MARC Project Title: US Department of Energy – Renew America’s Nonprofits Grant Program

**Federal Grant Recipient: Mid-America Regional Council Community Services Corp.
DE-SE0001001**

REQUEST FOR PROPOSALS FOR BUILDING ENERGY IMPROVEMENTS

ADDENDUM #1

1 NUMERATION PLAN - BASEMENT
3/32" = 1'-0"

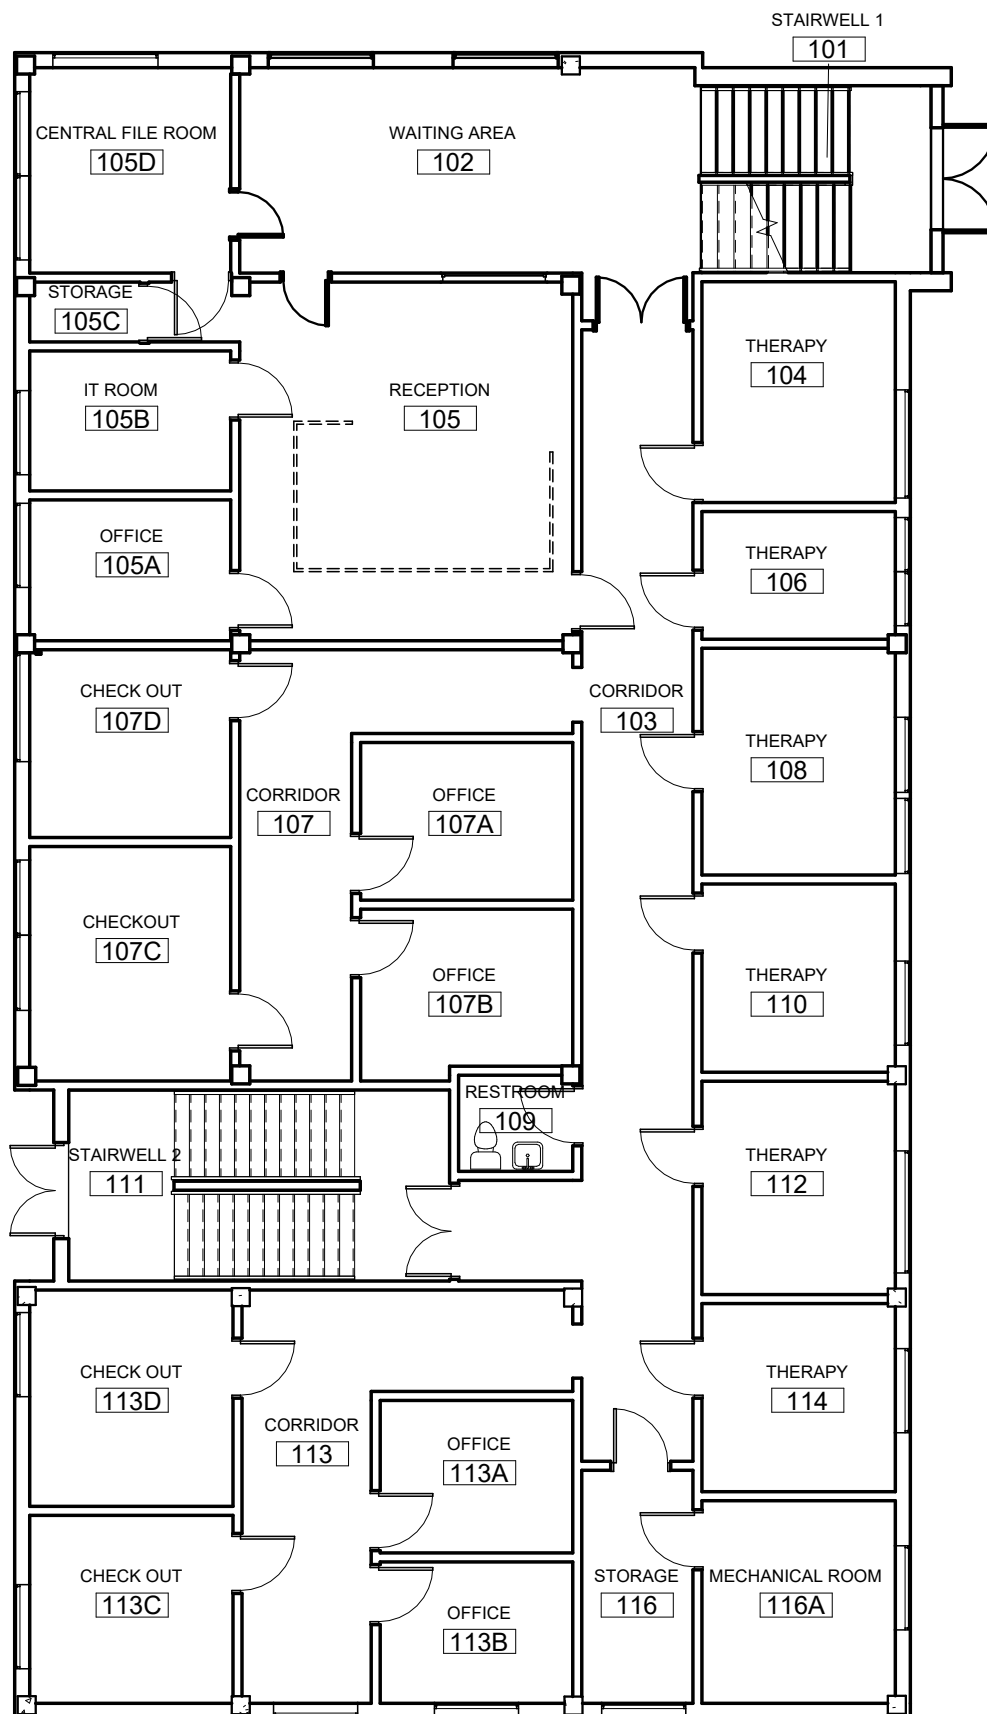
- 1. Clarifications from the Site Walks**
- 2. Q&A**
- 3. Site walk sign-in sheets**
- 4. Drawings**
 - a. Mattie Rhodes Center Numeration**
 - b. Samuel U Rodgers Health Center – latest addition the building (2nd floor)**
 - c. Hope Faith Ministries Master Plan**
 - d. Hope Faith Ministries Drawings**
 - e. Jewish Vocational Service Floor Plan**
 - f. Cornerstones of Care photos**
 - g. Synergy Services Building Plan and HVAC Specifications**
 - h. YMCA – Linwood Branch – Fan Details**
 - i. Linwood Property – 3210 Michigan HVAC photo**

SAM RODGERS HEALTH CENTER
2121 SUMMIT, KCMO

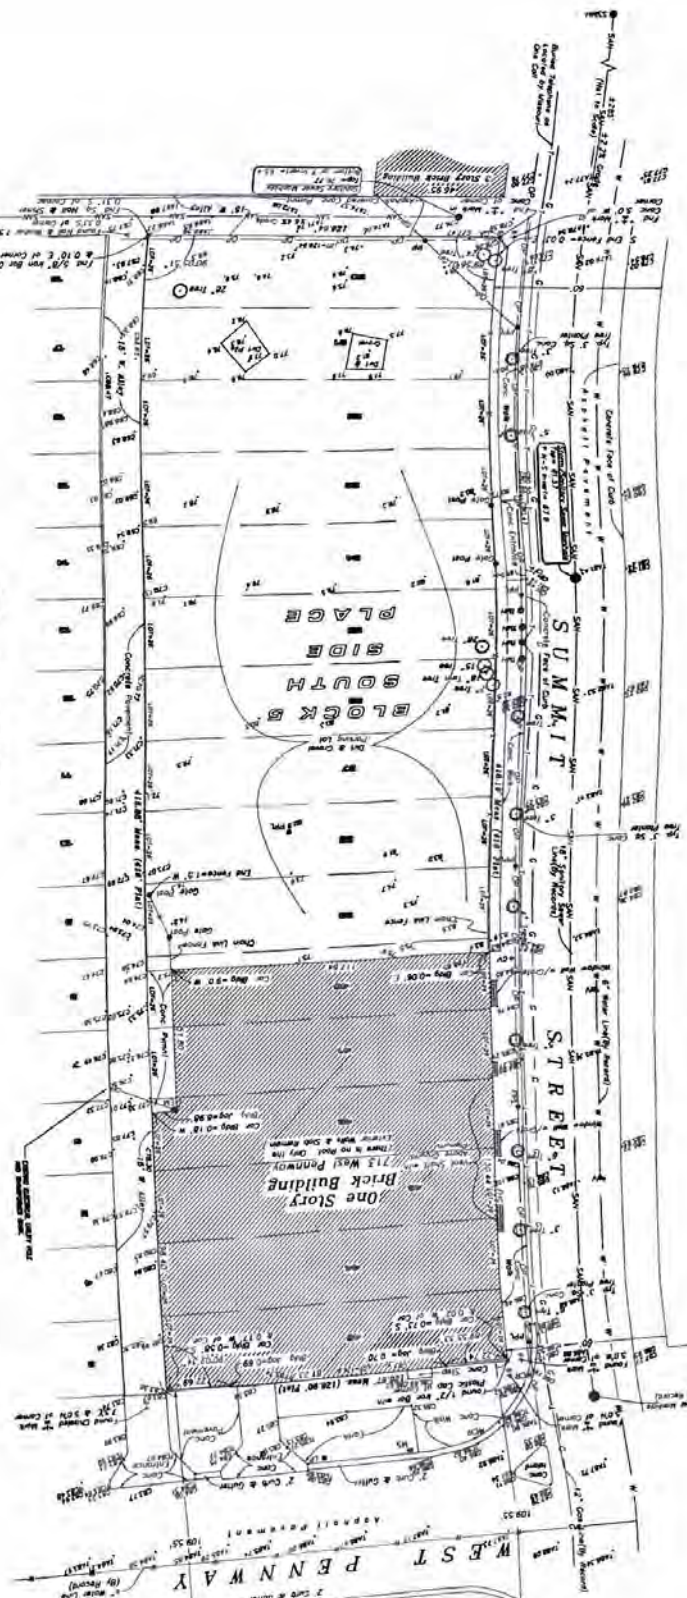
1. Provide hail guards on all units.
2. **Sam Rodgers Health Center:**
 - a. Although the bid language is written around Trane as the basis of design the facility is open to other manufacturers if they are an equal product.
 - b. Add Alternate 1: Smart thermostats that include occupancy, seasonal scheduling, remote access/control, and weather sensing are required. Thermostats need to be tamperproof to prevent changing energy-saving temperature setpoints.
3. **Synergy Services:**
 - a. Base Bid Clarifications: Synergy will not need to replace the small window unit "10 kBtu R-22 portable AC in the server room."
Synergy has the original load calculations and wants to replace the RTUs shown below 1:1.

Unit #	Make	Model	Serial #	Tons	Original Curb size	Adapter size
1	York	ZF048N10A2AAA2A	N1L2250986	4	40" x 70"	42" x 72"
2	Carrier	48TCEA06A2A5A0A0A0	3411C77085	4	40" x 70"	46 x 74.38
3	York	ZF048N10A2AAA2A	N1A3386256	4	40" x 70"	42" x 72"
4	York	ZF060N10A2AAA5A	N1B2592741	5	41" x 71"	45" x 82"
5	York	ZF036N08A2AAA2A	N1H2072621	3	40" x 70"	42" x 72"
6	York	ZF090N15N2AAA5A	N1A3449365	7.5	53" x 82"	55" x 83.5"
7	York	ZF048N10A2AAA2A	N1A3457653	4	40" x 70"	42" x 72"
8	York	ZF036N08A2AAA2A	N1N2341908	3	41" x 71"	42" x 72"

Cornerstones of Care Photos

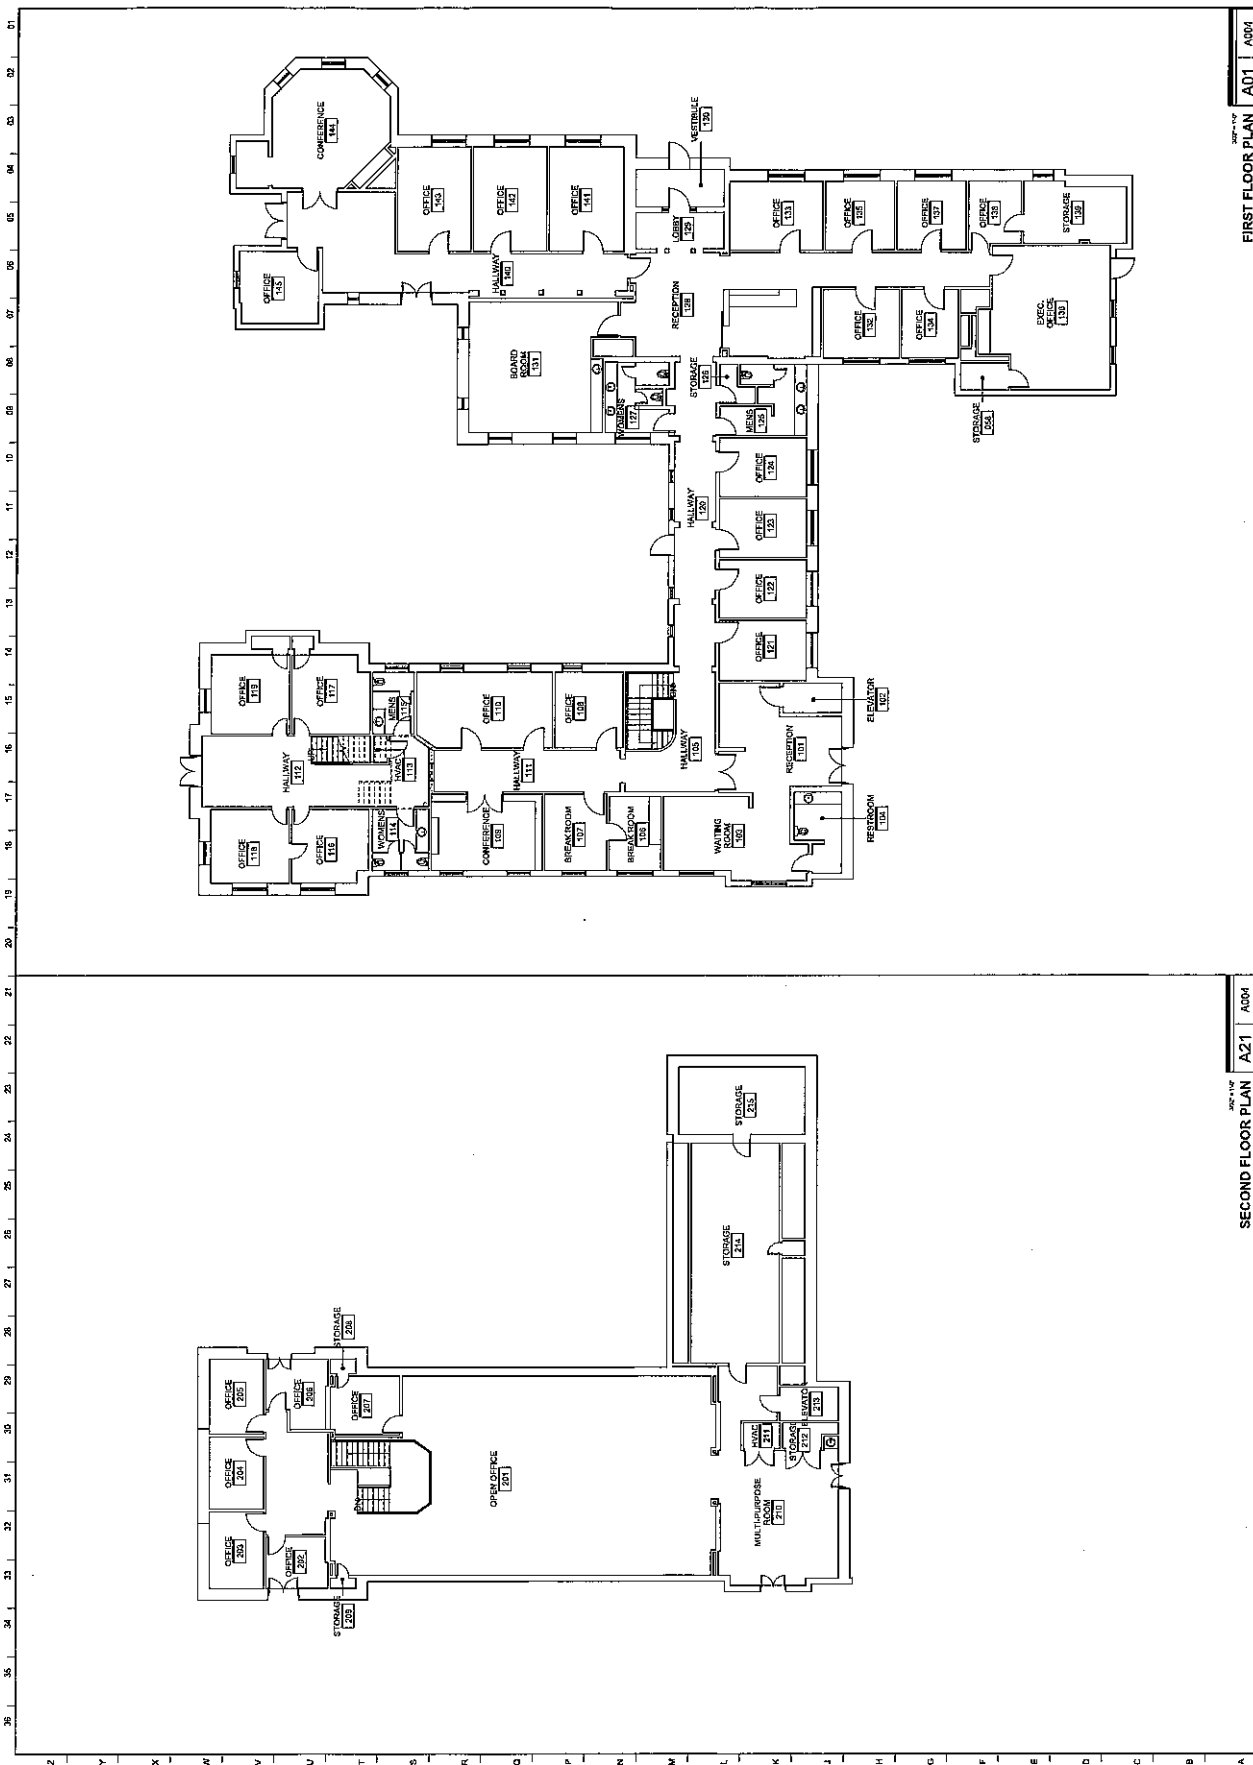
8. **Cornerstone of Care** has clarified their priorities:

a. Base Bid: HVAC Units for Replacement:

1. RTU-SW – Southwest rooftop unit, Lennox, 3 tons.
2. RTU-SE – Southeast rooftop unit, Carrier, 4 tons.
3. RTU-NE- Northeast rooftop unit, Carrier 4 tons
4. Kitchen rooftop unit – Exact model and capacity still need to be confirmed.

b. Alternate 1: Electrical Panels for Replacement:

- Two existing electrical panelboards located in the upper main electrical area of CYR Hall. Both panels have been identified and photographed.

c. Alternate 2: Additional Required Replacement:

- The existing domestic hot water heater serving the kitchen is also a priority and needs to be included in the project.
